NO.	DATE	BY	CHKD	ENGR	PROJ	DESCRIPTION
C	5-22-96	CLP	WR			BID ADDENDUM #2
B	4-19-96	DG	MP	MN	TDM	FINAL DESIGN REVIEW & BID
A	10-31-95	SG	MP	MN	TDM	PRELIMINARY DESIGN REVIEW

LASER INTERFEROMETER  
 GRAVITATIONAL-WAVE OBSERVATORY  
 SITE NO. 1 - HANFORD, WASHINGTON

**PLUMBING  
 MID & END STATIONS  
 FLOOR PLAN**

**WA-P-211**

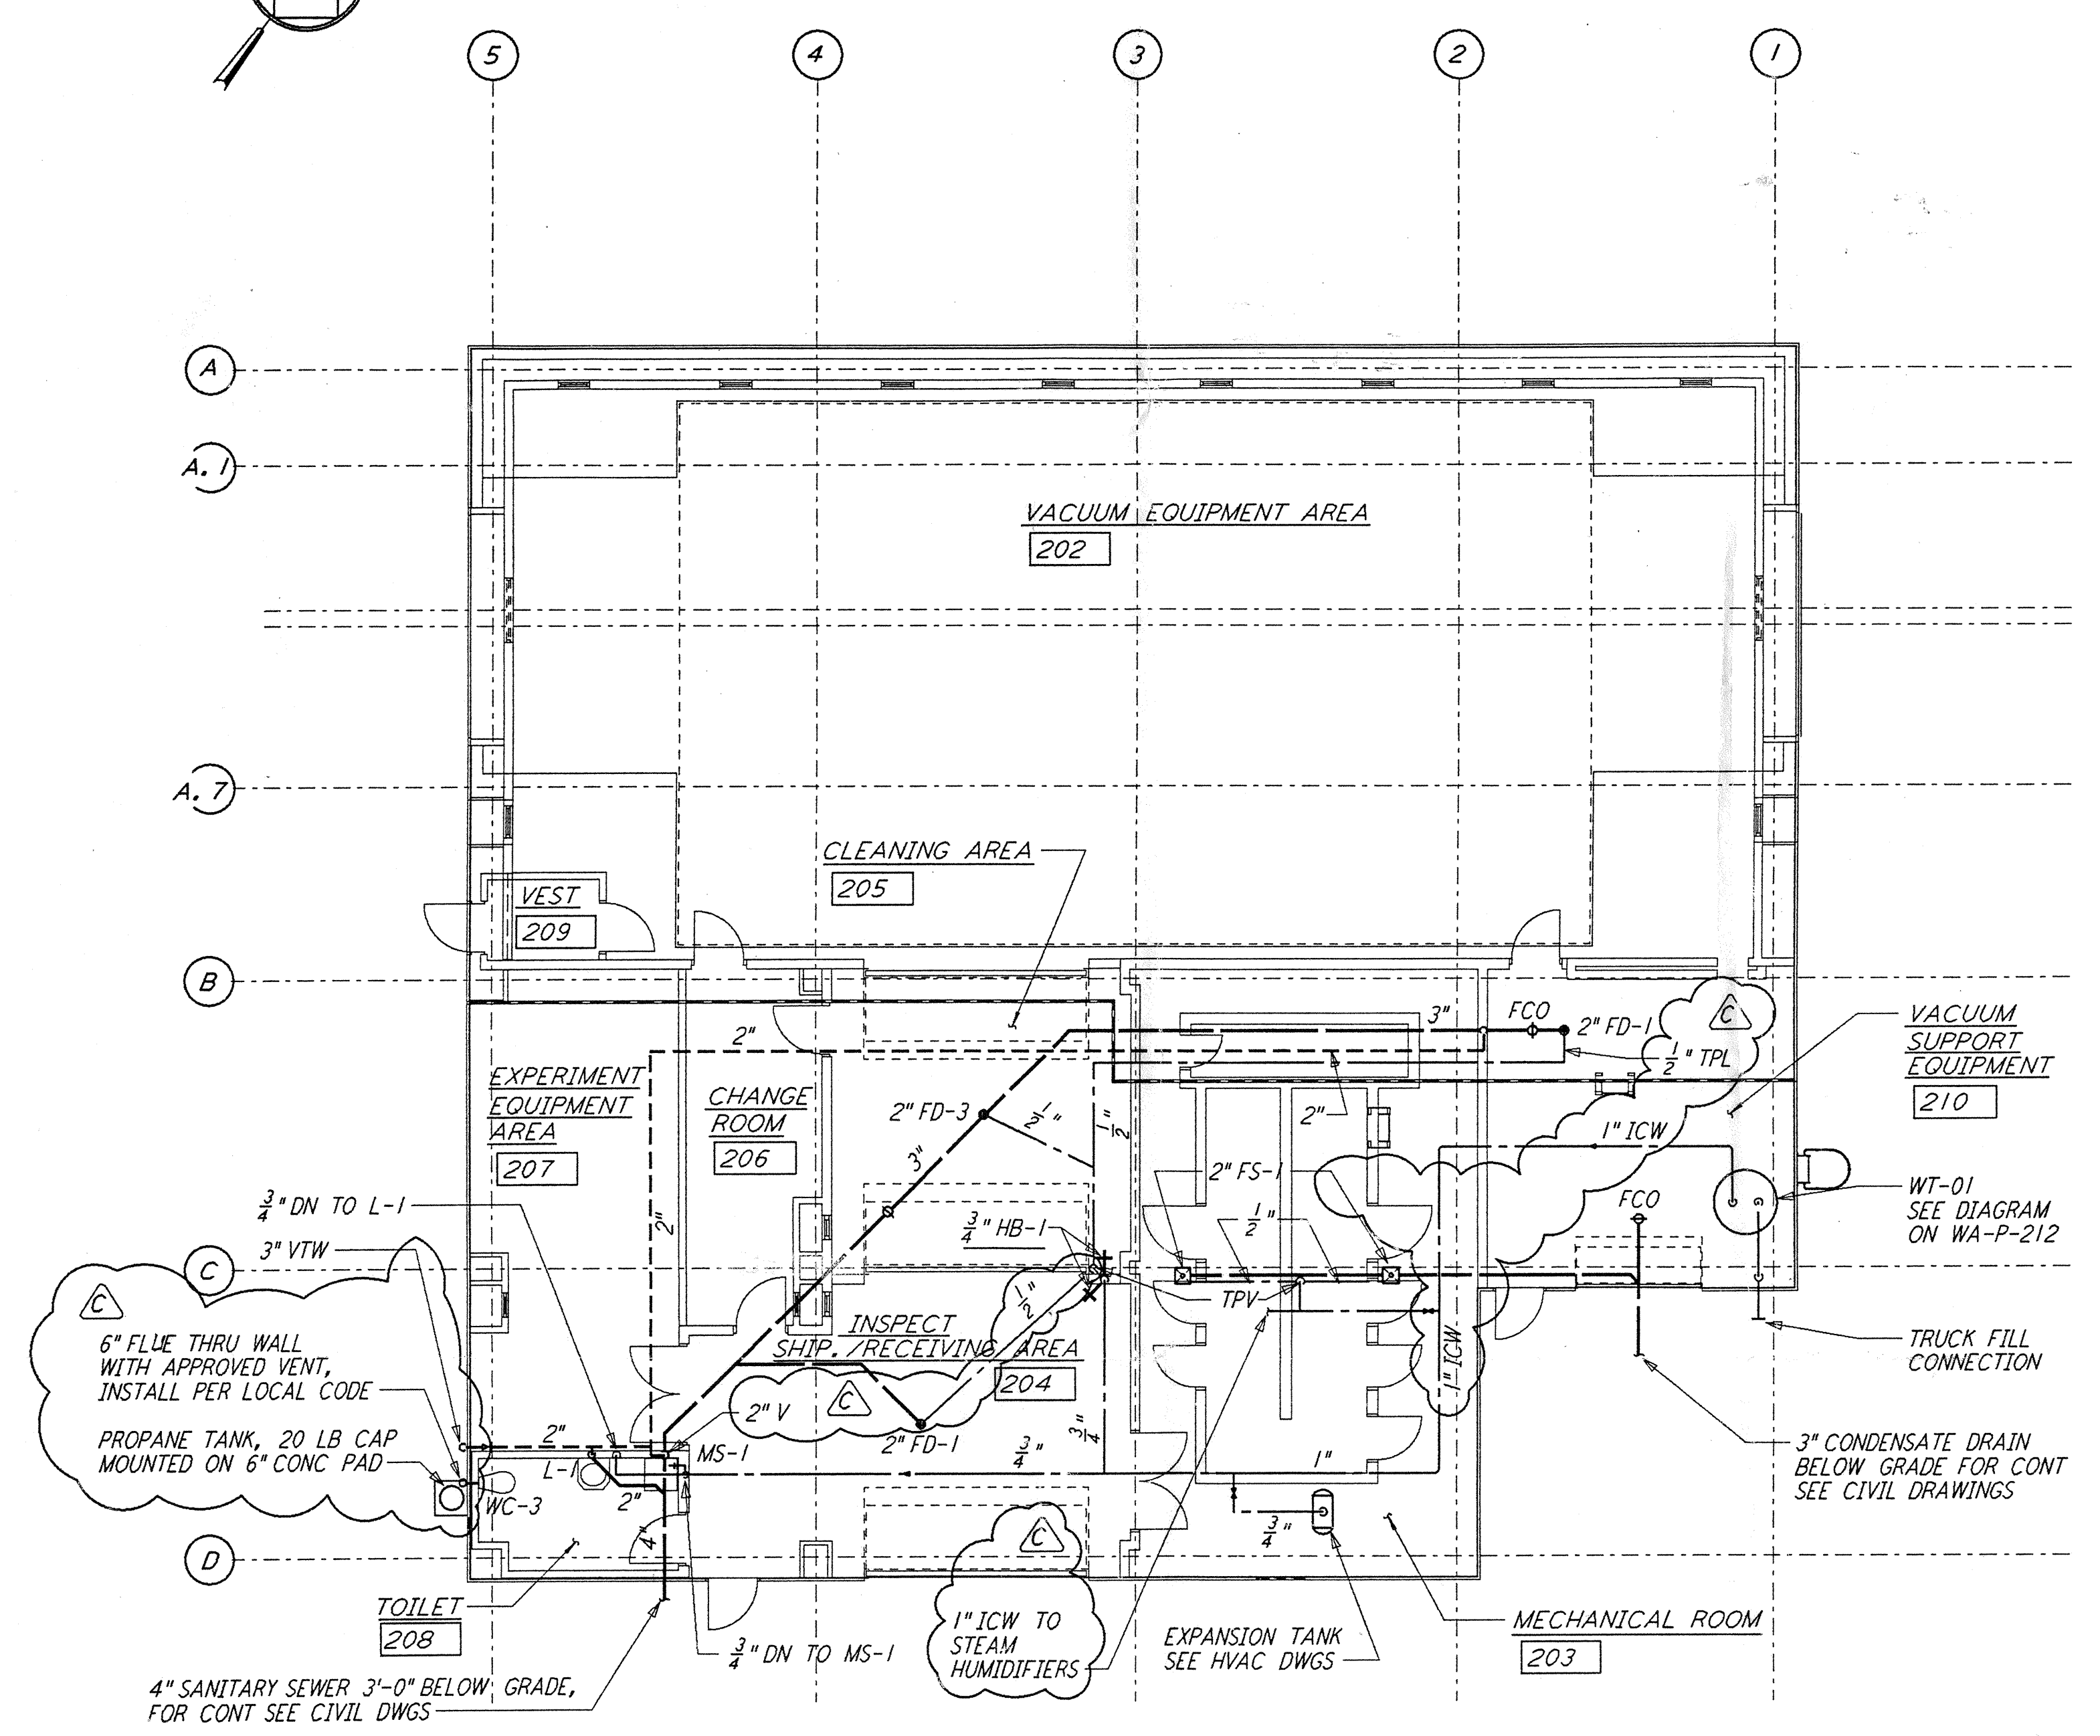
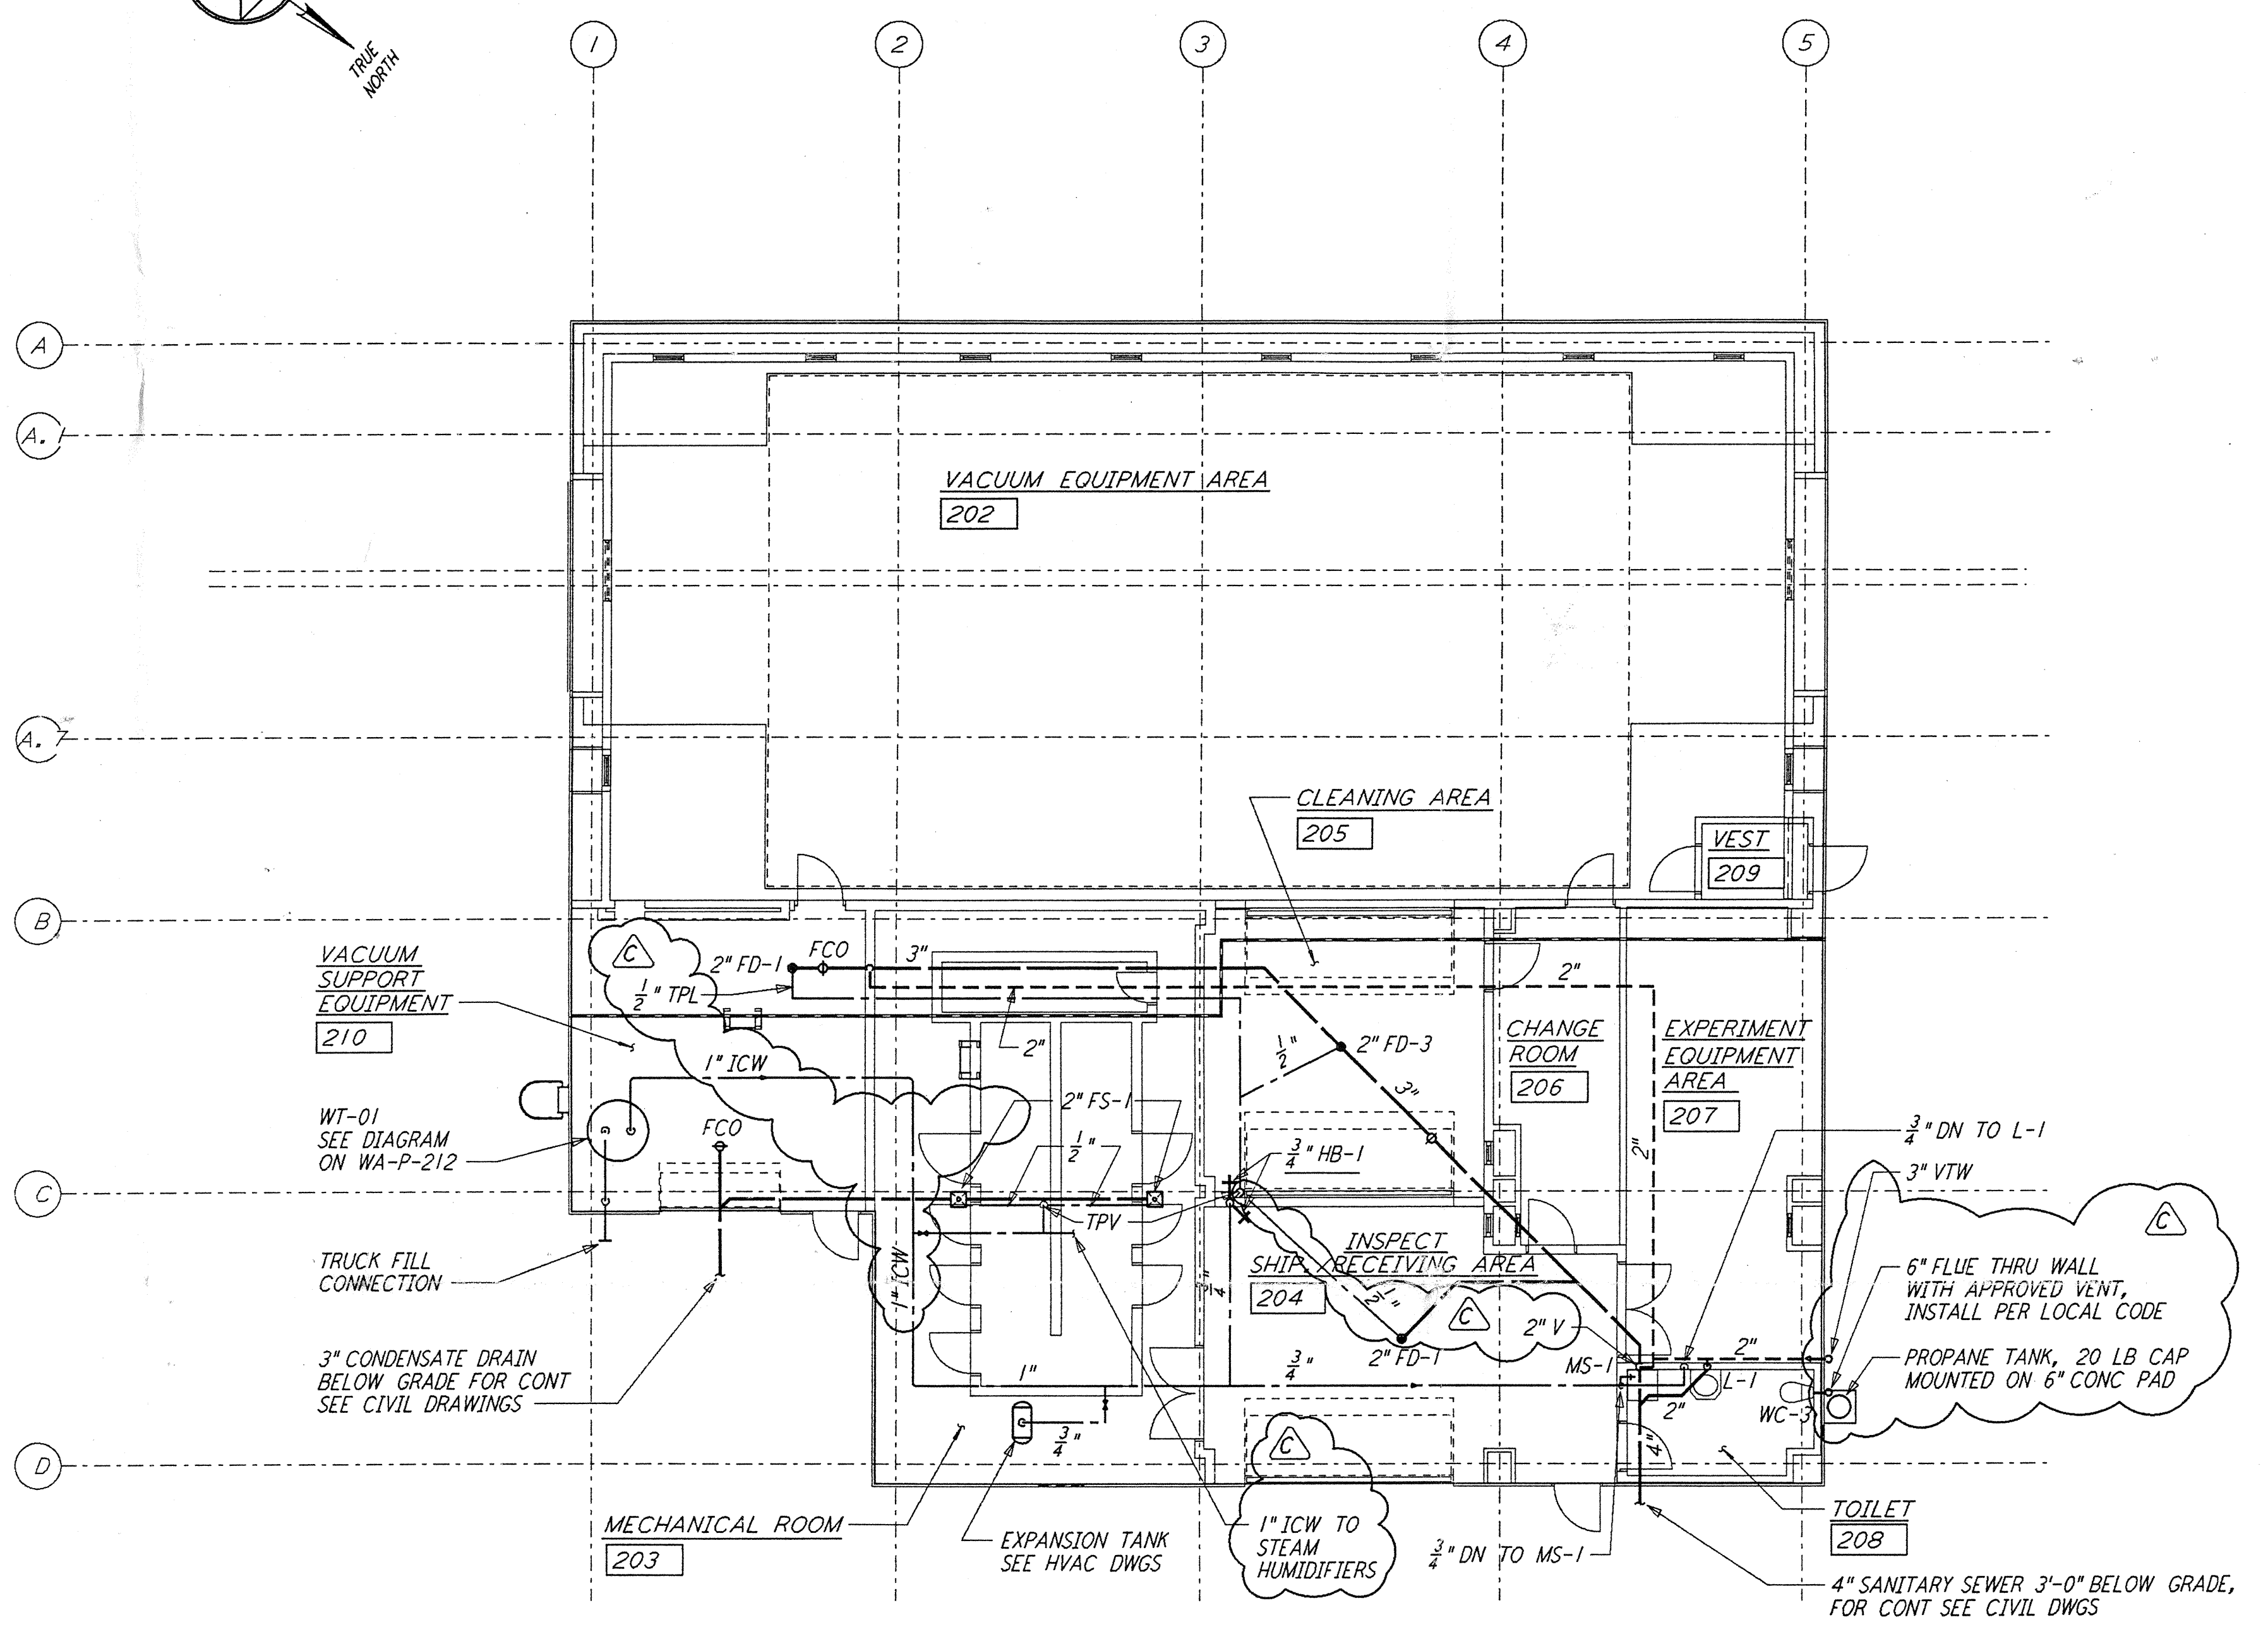
**NOTE:**  
 1. PROVIDE SIGNS AT ALL WATER OUTLETS IN THE MID AND END STATIONS STATING "DANGER - UNSAFE WATER"  
 2. THE WORK MARKED BY HAND ON THIS DRAWING IN REV "B", DATED 4-19-96 HAS BEEN RESTORED TO THIS CONTRACT.
